REGULAR MEETING OF
THE PLANNING COMMISSION
JANUARY 21, 2021 AT 6:00
PM
ATTEND VIRTUALLY

1. **Case #2020-2924. Vista de La Sierra Final Subdivision Plat.** JenkinsGavin, Inc., Agent, for Branch Family Holdings, LLC, Owner, requests a final subdivision plat for a 393 single family residential lot subdivision. The property located at 3800 Governor Miles Road, is approximately 94.07 acres and is zoned R-5 (Residential-five dwelling units per acre). (Donna Wynant, AICP, Case Manager, djwynant@santafenm.gov, 955-6325).

C-500

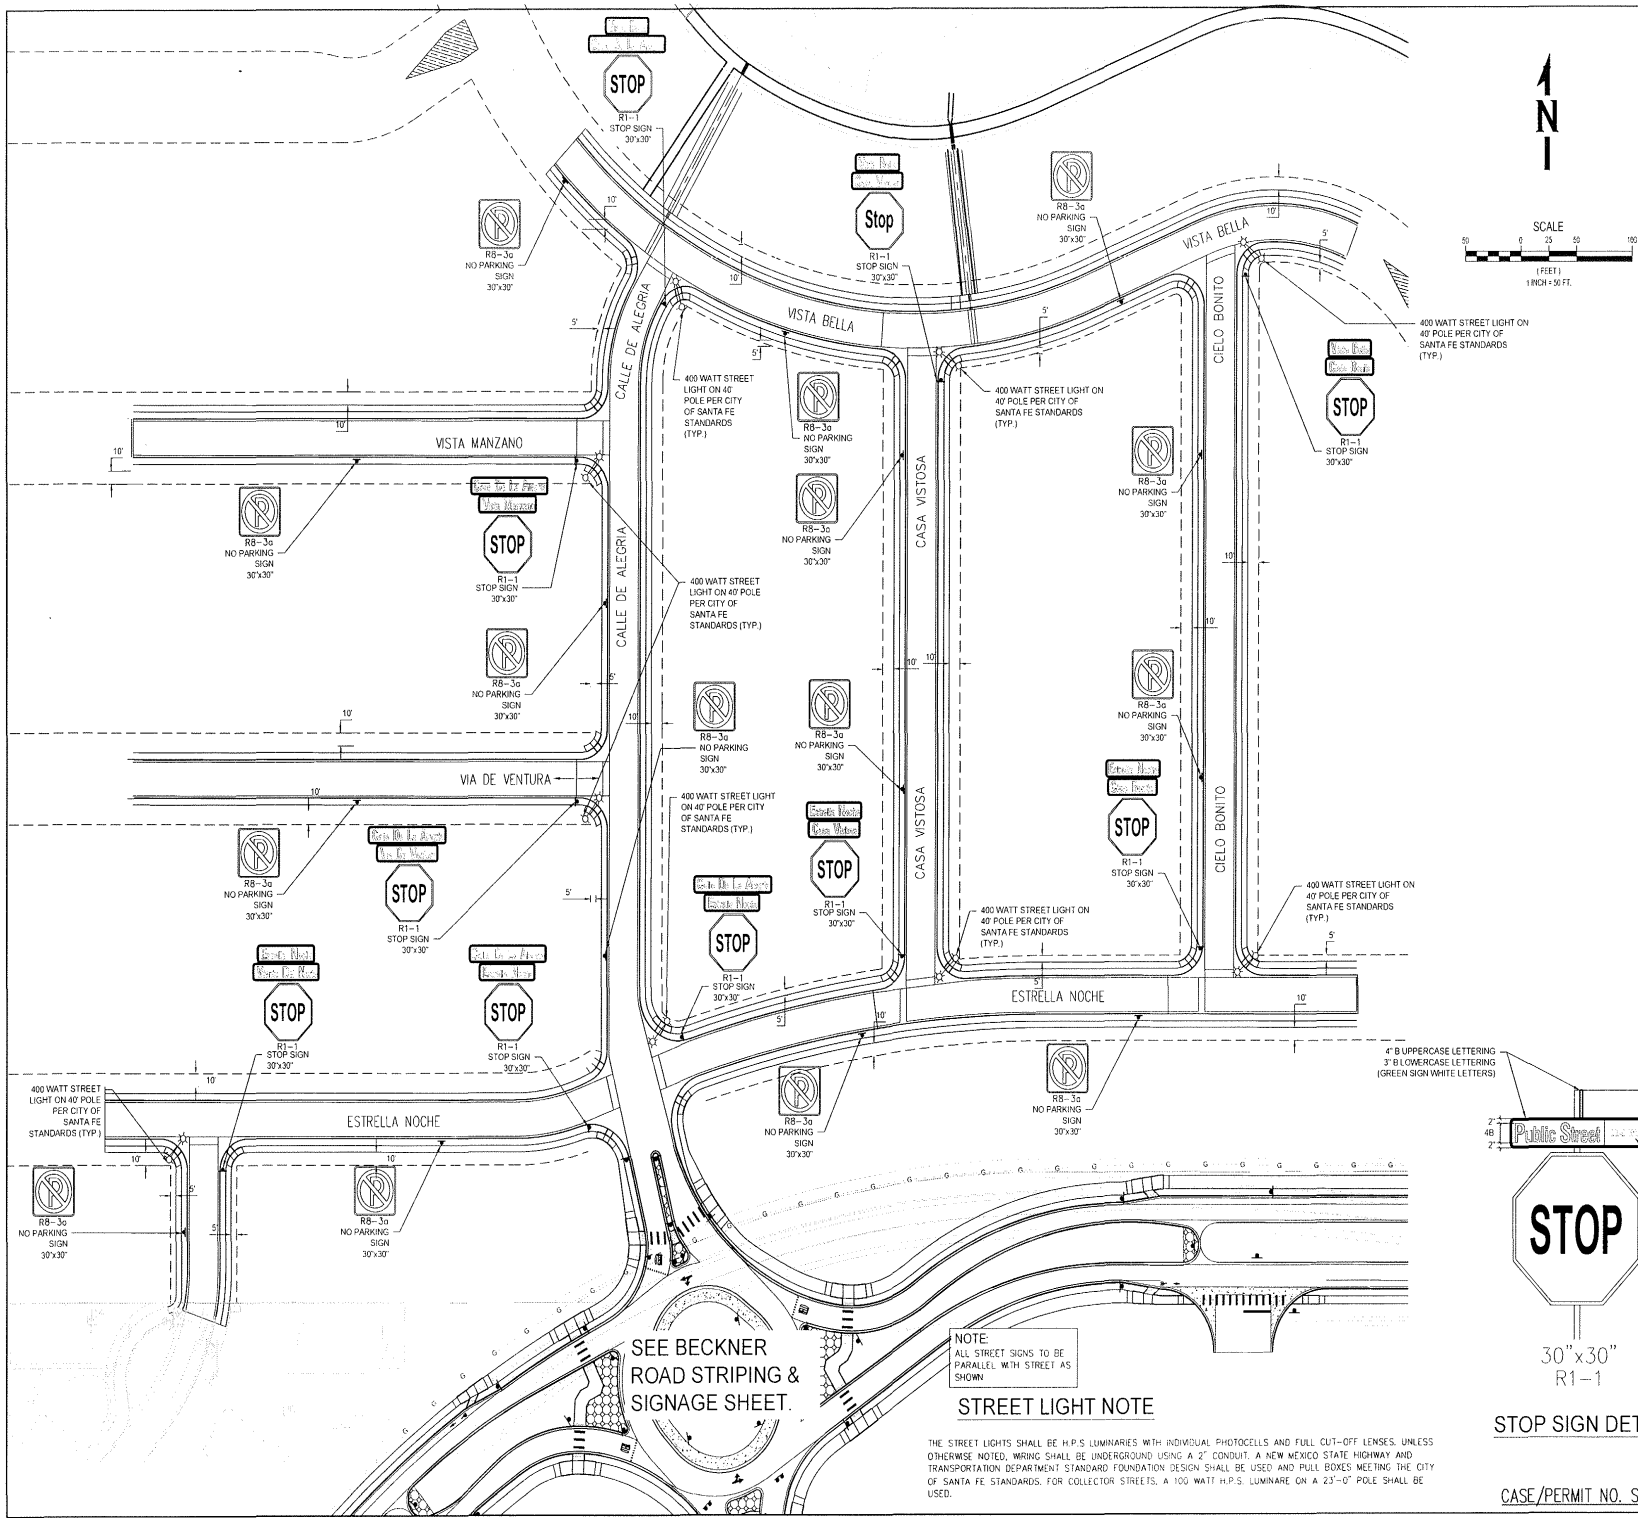
20. Sheets C-500 thru C1-600. Provide signage and striping for proposed round about.
21. Sheet C-900. Provide untreated base coarse under roadway. Provide more detailed pond sections for each pond with overflow. Need to discuss sides and bottoms of proposed ponds. Provide 4" to 6" rock for drainage swales.
